TECHNICAL BULLETIN

Re:
Replacing the panhard rod ball-joint bracket bolts.

Bulletin number:
VBA-TB2020-003-ALL

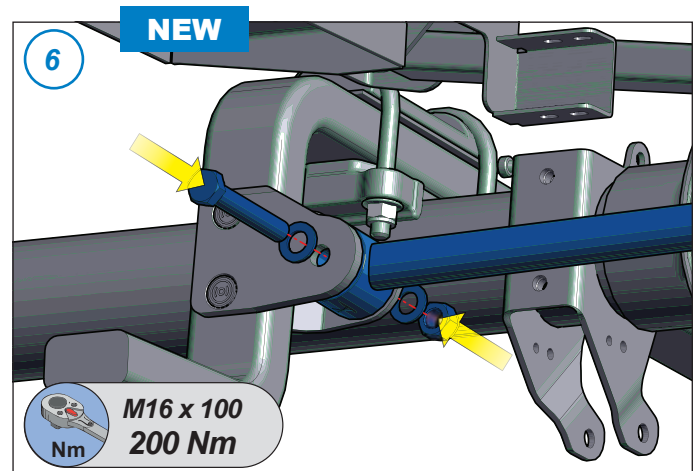
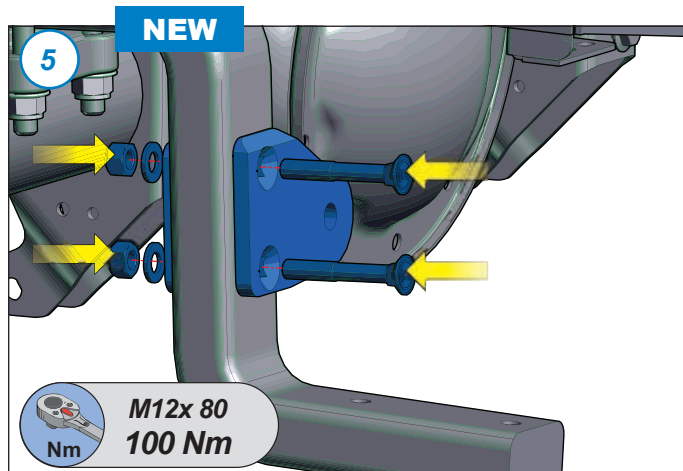
Picture 1: "wrong plough bolt type" Please exchange and discard. Fit new locking nuts and take notice of assembly instructions.

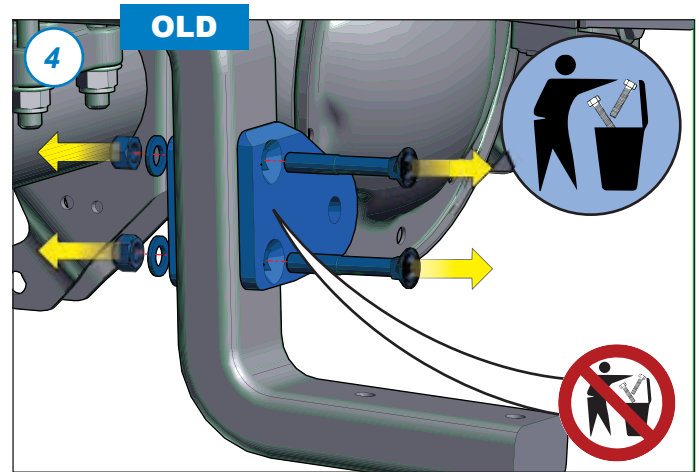
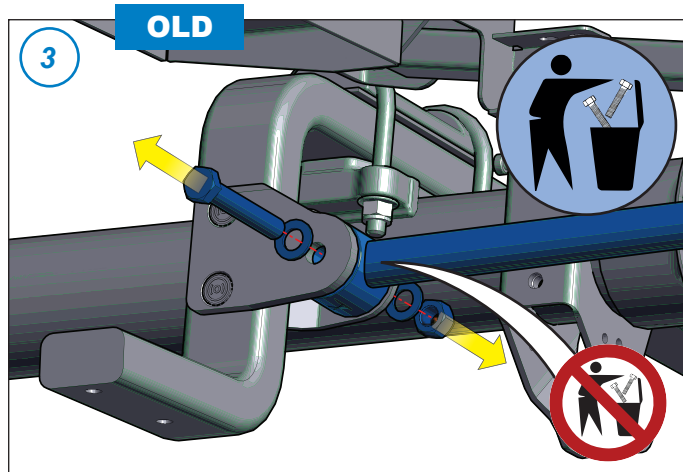
Picture 2: "Correct plough bolt type". No further action needed.
